EXCAVATION AND FLOOD PROTECTION - 17TH STREET CANAL CAPPING OF FLOODWALLS EAST SIDE LEVEE IMPROVEMENTS

AMENDMENT OF SOLICITATION/MODIFICATION OF CONTRACT 1. CONTRACT ID CODE PAGE OF PAGES
1 8

2. AMENDMENT/MODIFICATION NO. 0002	3. EFFECTIVE DATE 05/28/93	4. REQUISITION/PURCHASE REQ. NO. ED0000-3336-0063	5. PROJECT NO. (If applicable) dkn
6. ISSUED BY US ARMY ENGR DIST NEW ORLEANS PO BOX 60267 NEW ORLEANS LA 70160-0267 Molly M. Block		7. ADMINISTERED BY (If other than Item 6) US ARMY ENGR DIST, NEW ORLEANS ATTN CELMN-CT PO BOX 60267 NEW ORLEANS LA 70160-0267	
CODE ISSUE1		CODE ADMIN1	
SC2 (504)862-2879

PLANS AND SPECIFICATIONS FOR LAKE PONTCHARTRAIN LA & VICINITY, HURRICANE PROTECTION PROJECT, HIGH LEVEL PLAN, 17TH ST. OUTFALL CANAL, FLOOD PROTECTION IMPROVEMENT PROJECT, CAPPING OF FLOODWALLS, EAST SIDE IMPROVEMENTS, ORLEANS PARISH, LA, ARE HEREBY AMENDED AS FOLLOWS:

SOUTHERN RAILWAY TO I-10 EAST PANEL LAYOUT

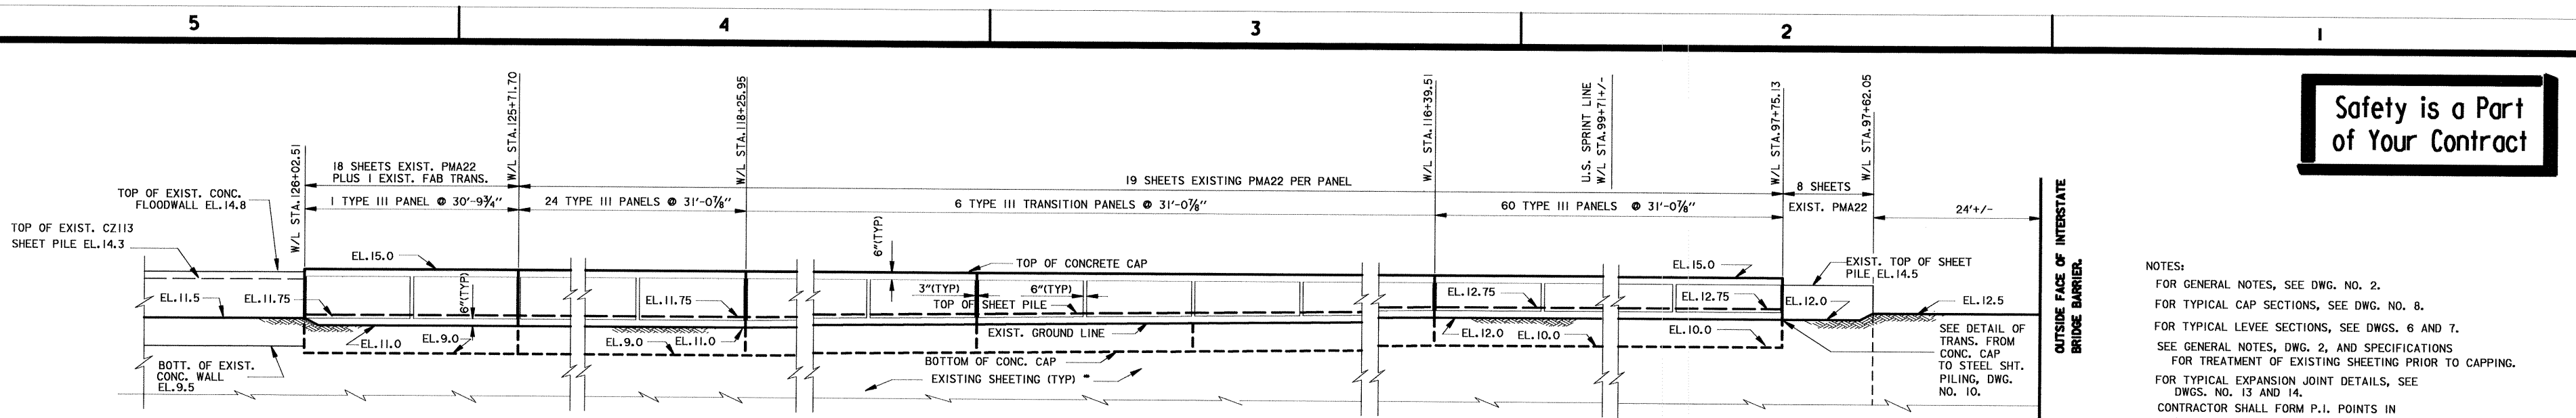
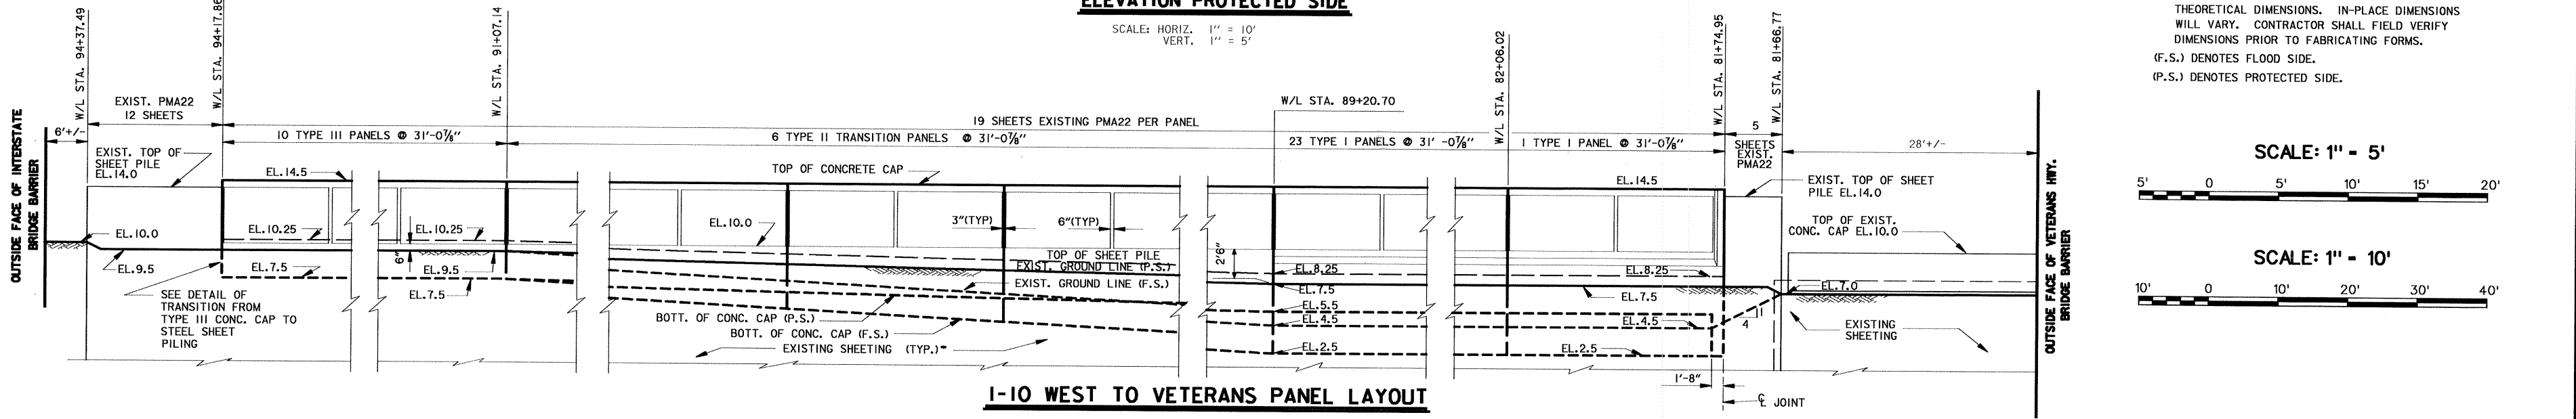
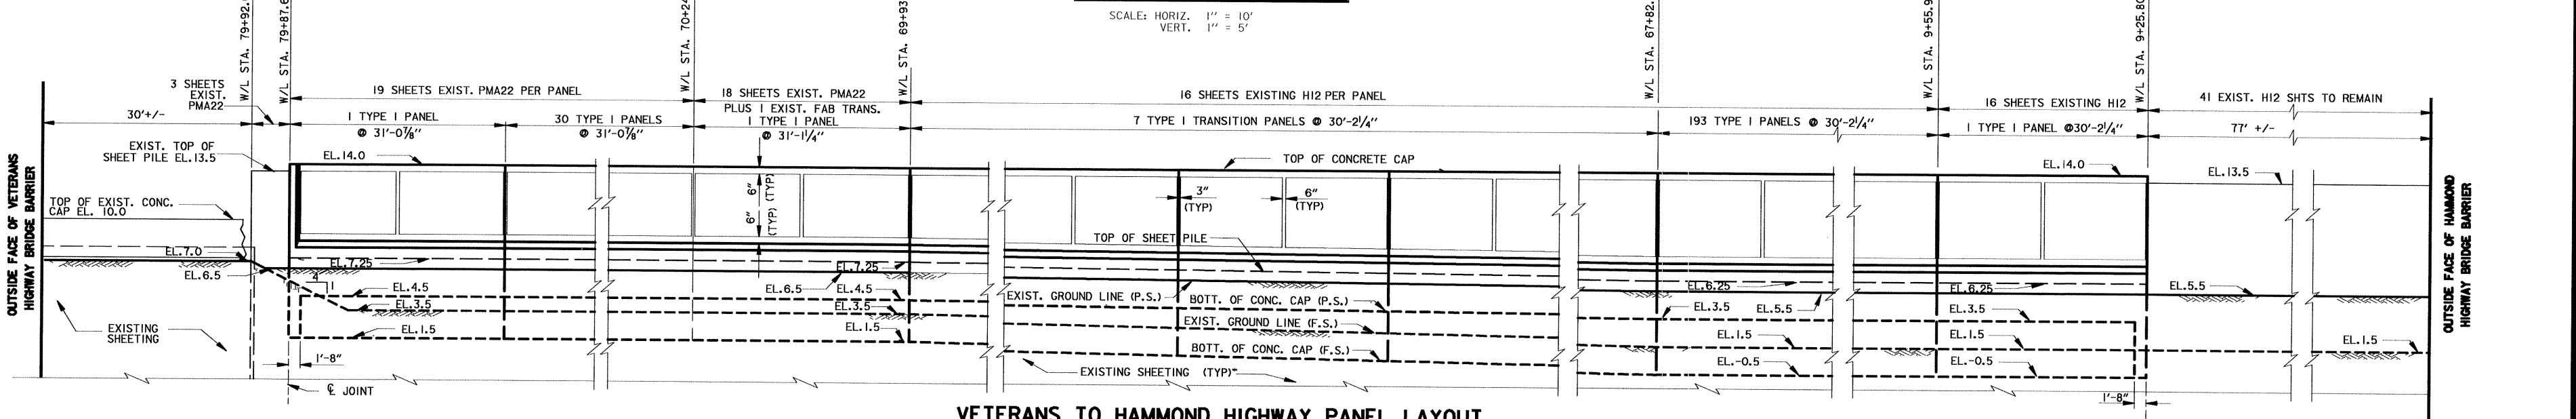
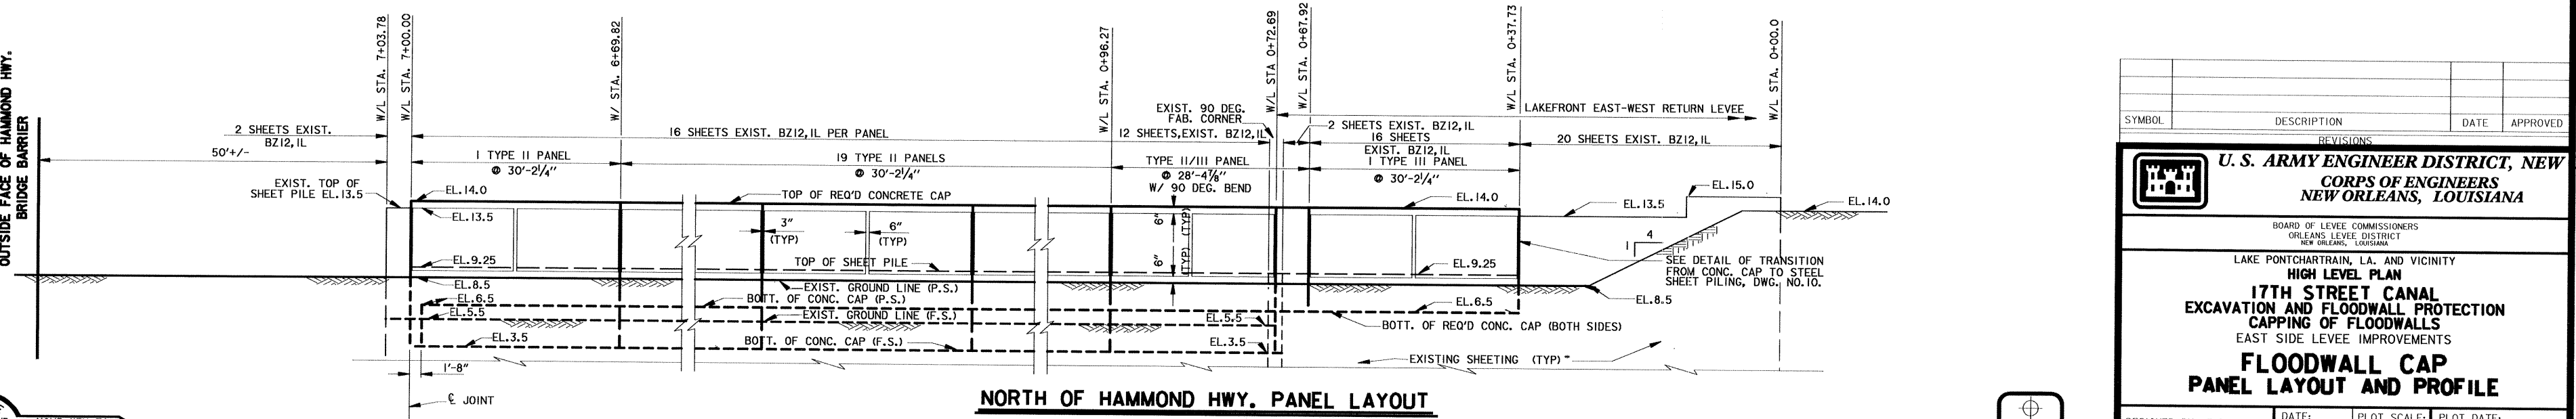
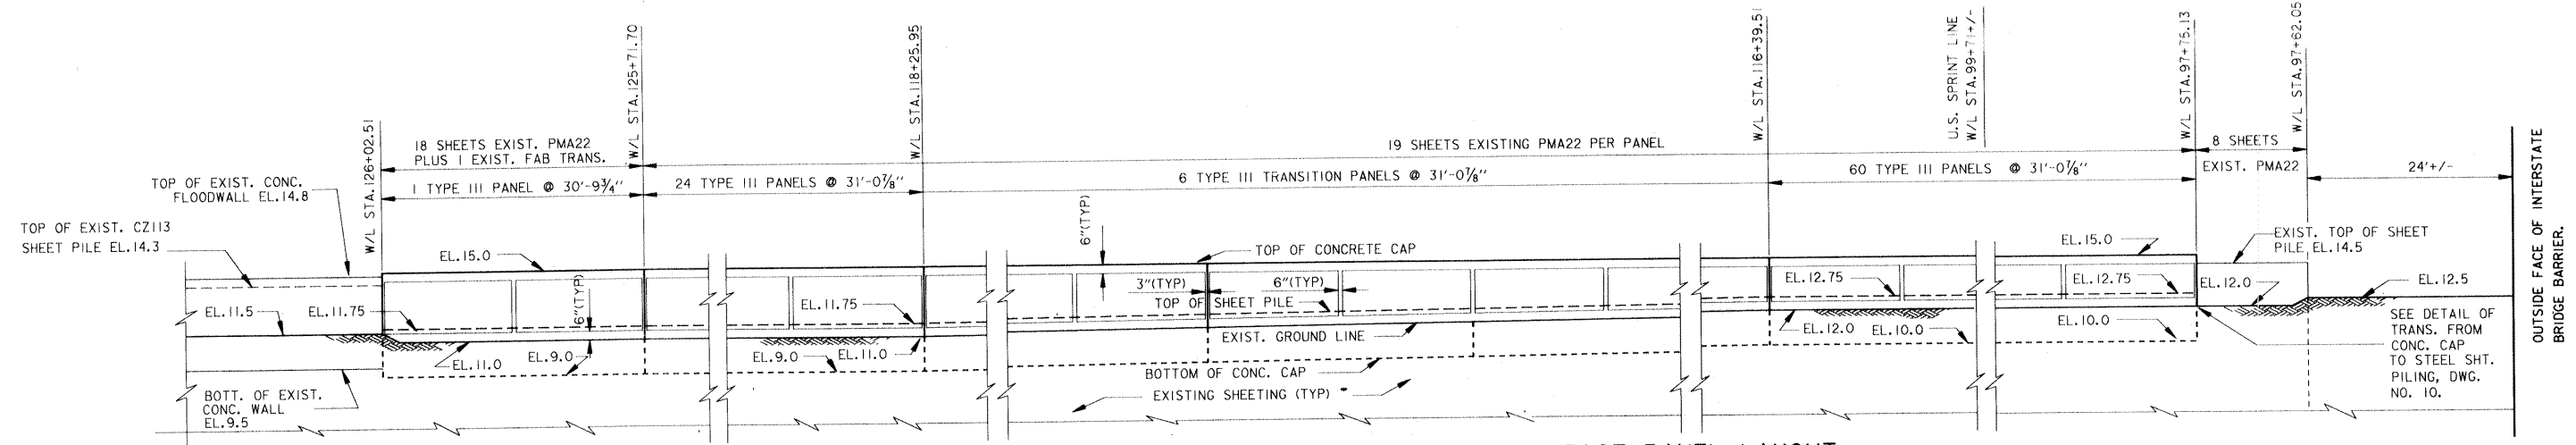
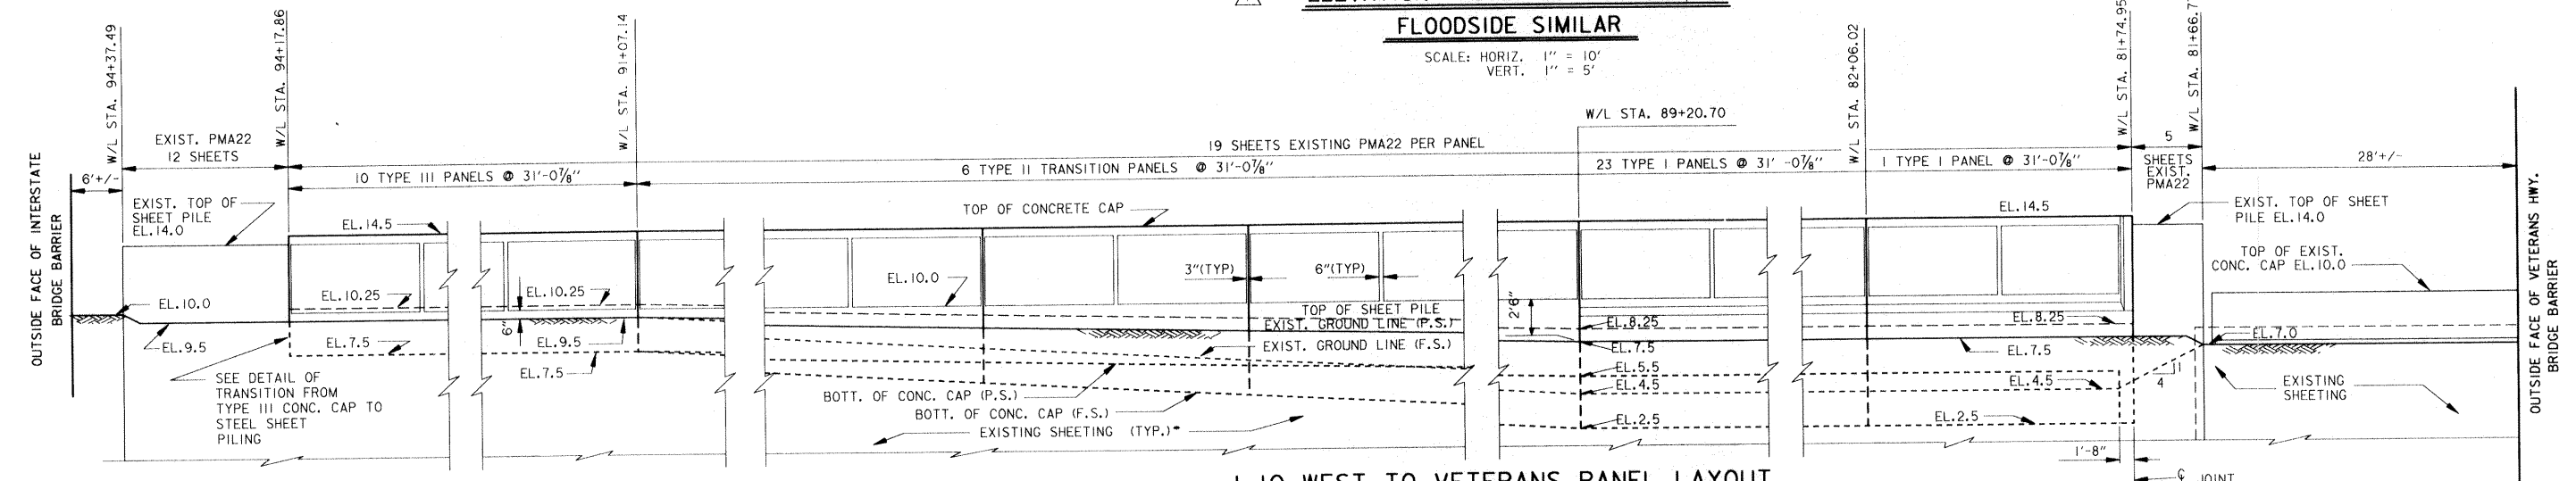
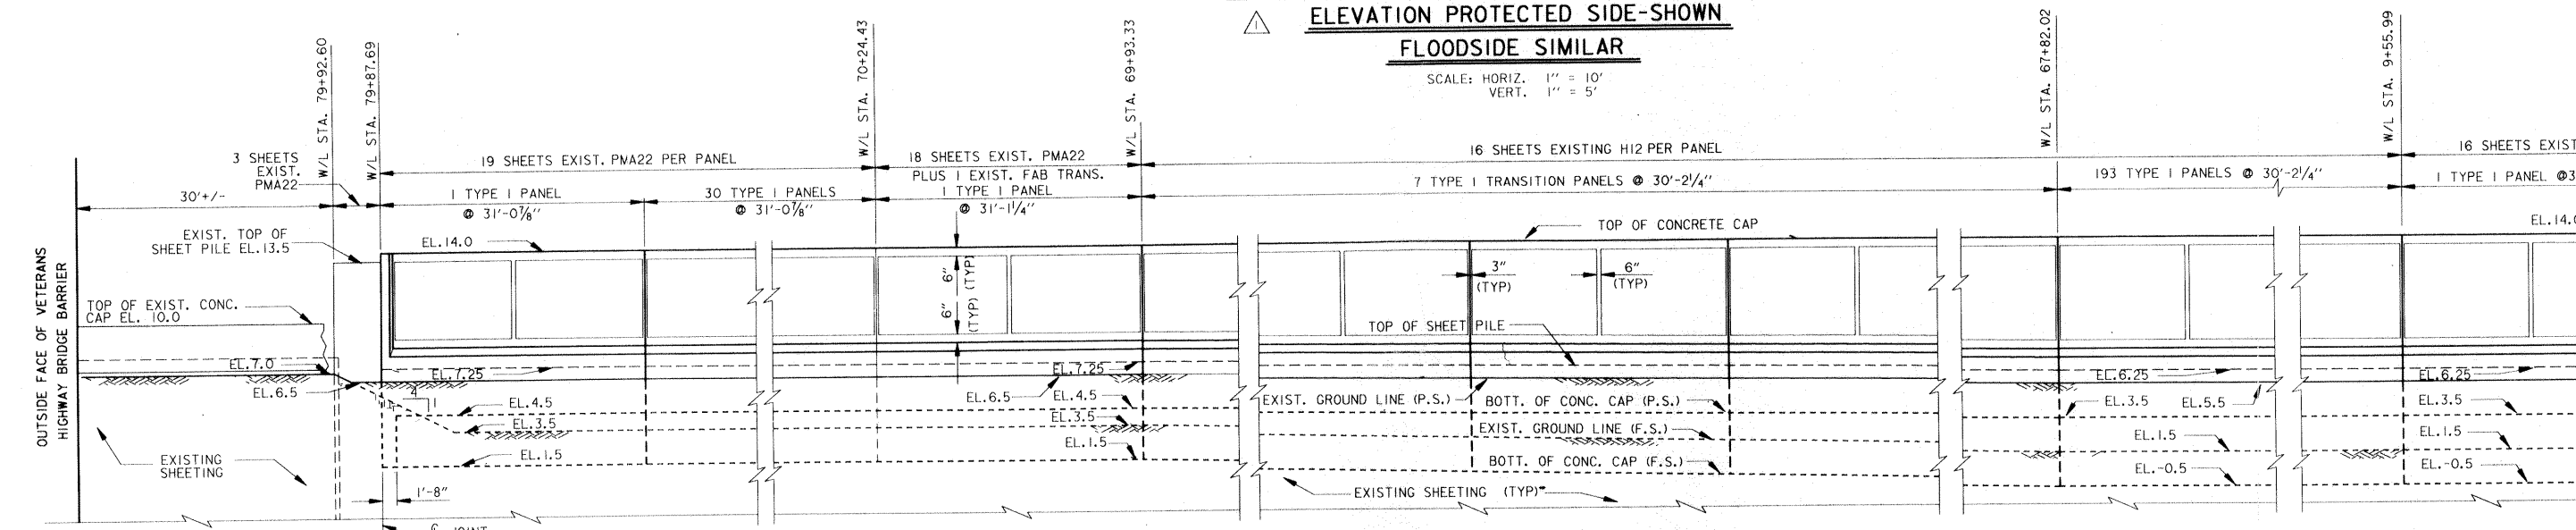
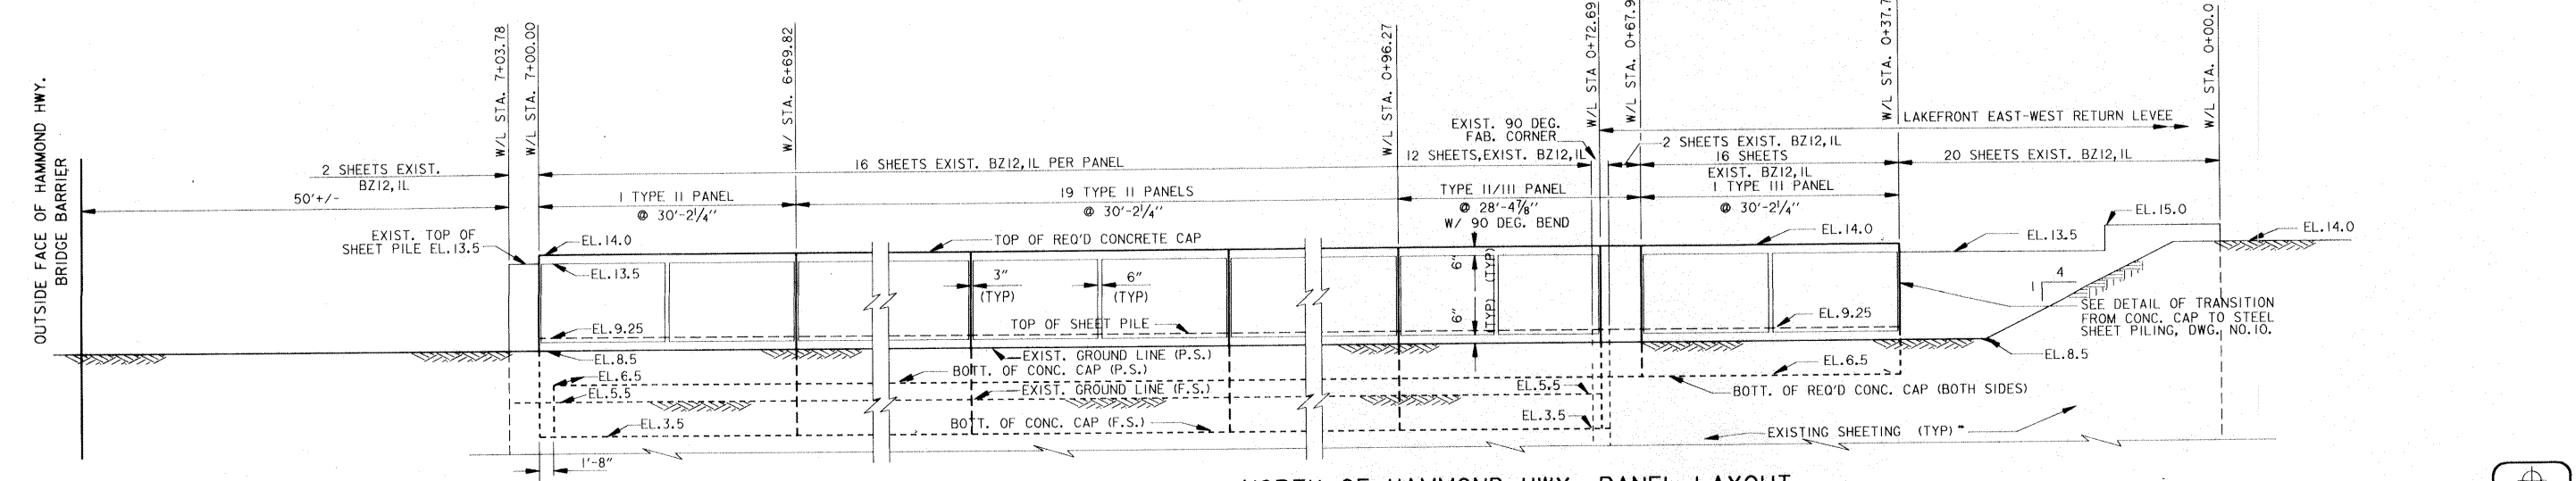
ADDED ARCHITECTURAL TREATMENT ON PROTECTED & FLOODSIDE OF WALL. AMEND. #2 DATE: 5/24/93 APPROVED: R.J.G.			
REVISIONS			
U.S. ARMY ENGINEER DISTRICT, NEW ORLEANS CORPS OF ENGINEERS NEW ORLEANS, LOUISIANA			
BOARD OF LEVEE COMMISSIONERS ORLEANS LEVEE DISTRICT NEW ORLEANS, LOUISIANA			
LAKE PONTCHARTRAIN, LA. AND VICINITY HIGH LEVEL PLAN 17TH STREET CANAL EXCAVATION AND FLOODWALL PROTECTION CAPPING OF FLOODWALLS EAST SIDE LEVEE IMPROVEMENTS FLOODWALL CAP PANEL LAYOUT AND PROFILE			
DESIGNED BY: F.S. DRAWN BY: P.M.R. CHECKED BY: M.L.S.	DATE: NOV. 1992	PLOT SCALE: 10	PLOT DATE: APR 1993
SUBMITTED BY: W.B. CONWAY MODJESKI & MASTERS, INC. DESIGN ENGINEER	CADD FILE: 40208X09.DGN	SOLICITATION NO. DACW29-93-B-0025	FILE NO. H-4-40208 DWG. 9 OF 16

NOTES:
FOR GENERAL NOTES, SEE DWG. NO. 2.
FOR TYPICAL CAP SECTIONS, SEE DWG. NO. 8.
FOR TYPICAL LEVEE SECTIONS, SEE DWGS. 6 AND 7.
SEE GENERAL NOTES, DWG. 2, AND SPECIFICATIONS FOR TREATMENT OF EXISTING SHEETING PRIOR TO CAPPING.
FOR TYPICAL EXPANSION JOINT DETAILS, SEE DWGS. NO. 13 AND 14.
CONTRACTOR SHALL FORM P.I. POINTS IN CONCRETE WALL AS REQUIRED BY ALIGNMENT OF SHEET PILE.
PANEL LENGTHS SHOWN ARE BASED ON THEORETICAL DIMENSIONS. IN-PLACE DIMENSIONS WILL VARY. CONTRACTOR SHALL FIELD VERIFY DIMENSIONS PRIOR TO FABRICATING FORMS.
(F.S.) DENOTES FLOOD SIDE.
(P.S.) DENOTES PROTECTED SIDE.
FOR ARCHITECTURAL TREATMENT OF WALL SEE TECHNICAL SPECIFICATIONS.
